RE: PCN # ESU270-30 – SESD Series Product Label Change

## Product/Process Change Notice (PCN)

SESD Series Products acquired from TE Connectivity Ltd

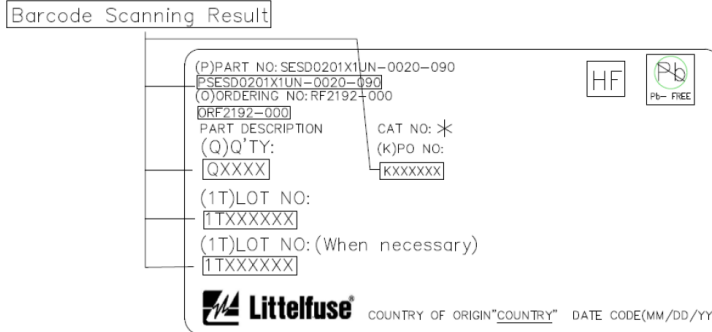
4.1 There will be no changes in the packing method but labeling information is changed to below
